From: simon@si-tecplans.co.uk
Sent: 21 April 2024 20:55
To: Jacques.Burrowes
Subject: RE: DC/24/0171 - Additional Information
Attachments: DWG 2.pdf

From: Jacques.Burrowes <Jacques.Burrowes@horsham.gov.uk>
Sent: Tuesday, March 19, 2024 11:39 AM
To: simon@si-tecplans.co.uk
Subject: DC/24/0171 - Additional Information

103 Rushams road
Horsham
West Sussex
RH12 2NY

Drawing Title **Elevations**

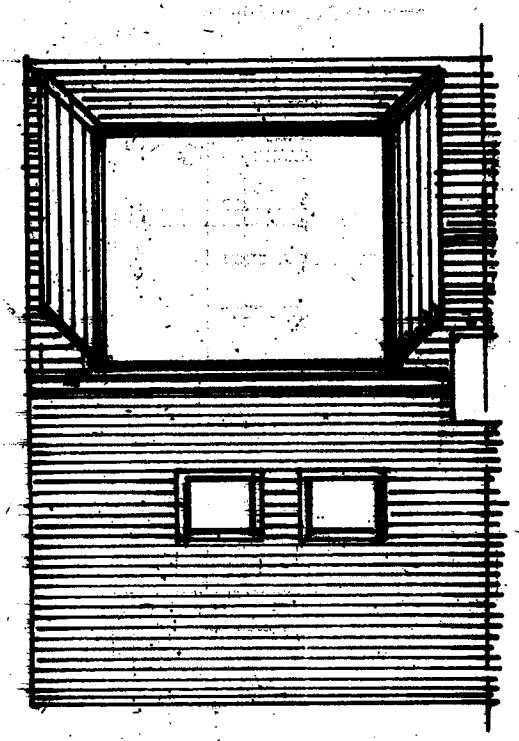
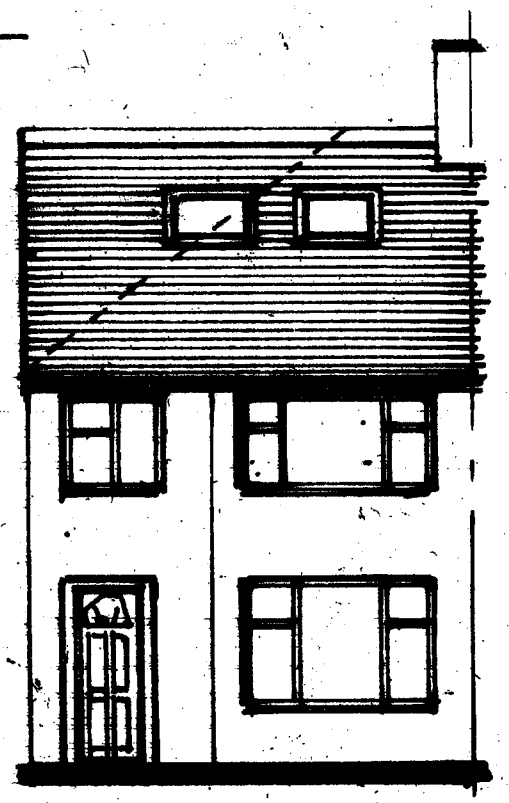
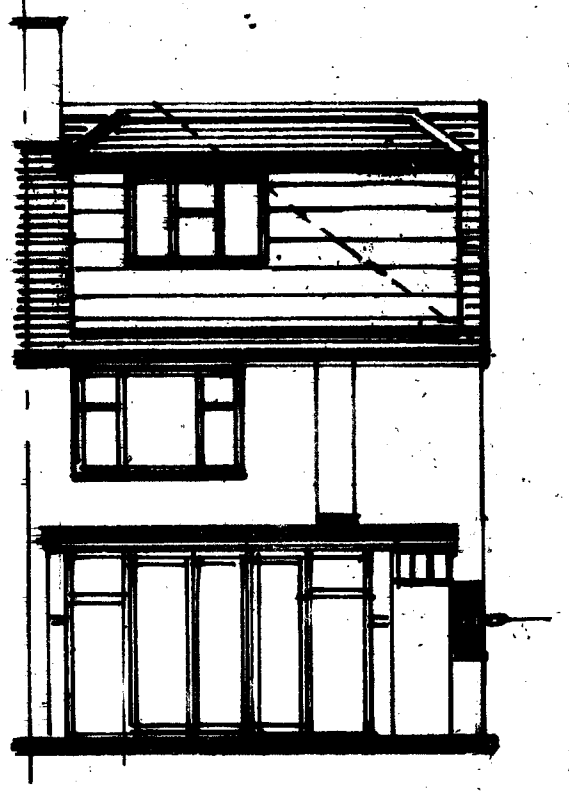
The plans do not seem to tally with the indicated dimensions from the specs you provided on the spreadsheet. The drawings measure the unit 1m in height yet the dimensions of the unit from the spreadsheet indicate the unit to be 550mm in height. Additionally, the unit's width and depth appear to be wrong on the drawing too. The unit is also indicated at 1.2m above the ground which looks to be incorrect from images. I have attached my measurement drawing to show this.

Can accurate plans be resubmitted that tally with the spec of the unit.

Is it possible that this unit can be mounted on the ground? This would help attenuate the noise from the unit as at the moment it can fire directly towards the neighbouring garden at its current height and would look less obtrusive. With the unit on the ground, the fencing would help in baffling the sound.

Amended Plans attached

The client would like to leave the unit as it is proposed
